APPLICATION NO.	F	ILING DATE	FIRST NAMED INVENTOR	ATTORNEY DOCKET NO.	CONFIRMATION NO.
10/759,877	10/759,877 01/16/2004		John Boyland	0403-4107	8433
27123	7590	03/02/2006		EXAMINER	
		EGAN, L.L.P.	SHARP, JEFFREY ANDREW		
3 WORLD FINANCIAL CENTER NEW YORK, NY 10281-2101				ART UNIT	PAPER NUMBER
				3677	•

Application No.	Applicant(s)				
		10/759,877	BOYLAND ET AL.				
	Office Action Summary	Examiner	Art Unit				
		Jeffrey Sharp	3677				
Period fo	The MAILING DATE of this communication app or Reply	ears on the cover sheet with the c	orrespondence address				
WHIC - Exter after - If NC - Failu Any	ORTENED STATUTORY PERIOD FOR REPLY CHEVER IS LONGER, FROM THE MAILING DANSIONS of time may be available under the provisions of 37 CFR 1.15 SIX (6) MONTHS from the mailing date of this communication. O period for reply is specified above, the maximum statutory period were to reply within the set or extended period for reply will, by statute, reply received by the Office later than three months after the mailing ed patent term adjustment. See 37 CFR 1.704(b).	ATE OF THIS COMMUNICATION 36(a). In no event, however, may a reply be tirr vill apply and will expire SIX (6) MONTHS from cause the a

Grieser et al. US-5,641,240

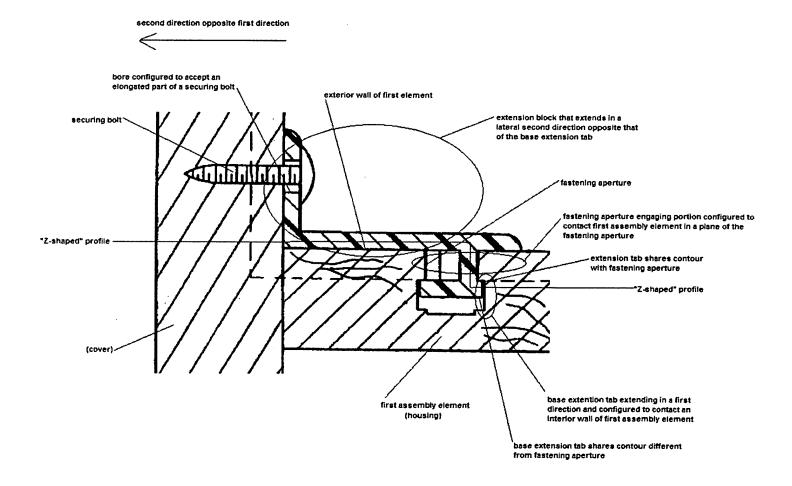
- (b) the invention was patented or described in a printed publication in this or a foreign country or in public use or on sale in this country, more than one year prior to the date of application for patent in the United States.
- [9] Claims 1-4, 7, 9, 12, 20, and 21 are rejected under 35 U.S.C. 102(b) as being anticipated by Grieser et al. US-5,641,240.

In short, Grieser et al. teach a Z-type fastener with a Z-shaped profile, used in a housing (94)/cover (92) assembly, said Z-type fastener having:

a base extension tab (76) being provided with a surface (72) configured to contact an interior wall of a fastening aperture (98) within said housing,

a fastening aperture engaging portion (64,80) (e.g., pressure application edge), an extension block/body (12,18,20,30) being provided with a surface (30) configured to contact an exterior wall of said housing;

wherein the extension block of the Z-type fastener has a bore (14) configured to accept an elongated part of a securing bolt/body (100), and

wherein the extension block extends in a lateral direction opposite that of the base extension tab.

Palumbo US-3,970,399

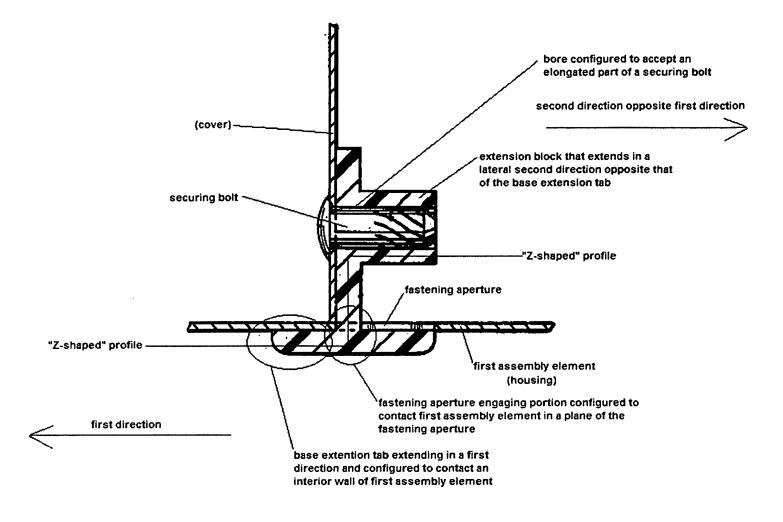
[10] Claims 1-4, 12, 13, 14 (as it is understood), 15, 20, and 21 are rejected under 35 U.S.C. 102(b) as being anticipated by Palumbo US-3,970,399.

In short, Palumbo teaches a Z-type fastener (10) with a Z-shaped profile, used in a housing (13)/cover (12) assembly (11), said Z-type fastener having:

a base extension tab (20') being provided with a surface (15) configured to contact an interior wall of a fastening aperture (27) within said housing,

a fastening aperture engaging portion (18) (e.g., pressure application edge), an extension block/body (17,23);

wherein the extension block of the Z-type fastener has a bore (24) configured to accept an elongated part of a securing bolt/body (32,33,34,35), and

wherein the extension block extends in a lateral direction opposite that of the base extension tab.

Palumbo US-3,970,399

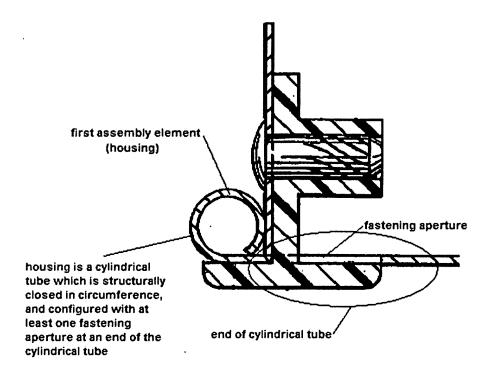
As for claims 13-15, Palumbo suggests that the housing may be a closed cylindrical tube having a fastening aperture at an end thereof. The Z-type fastener maintains a plurality of contact areas with the housing.
